Memo

date: August 27, 2010
to: RSC, C. Folz
from: D. Beavis *DB*
subject: Additional Penetration at 3 O'clock

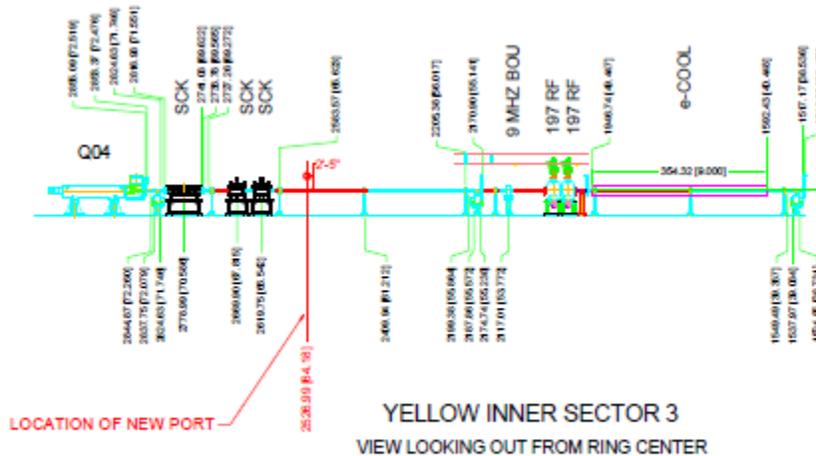
C. Folz has provided the figure below which depicts the entry of the penetration in the ring 2.5 feet above beam height.

The new penetration must be inspected prior to beam operations in RHIC to ensure that the assumptions on vertical displacement assumed in the radiation calculations are correct for the as built pipe. (CK-RHIC-HY11-725)
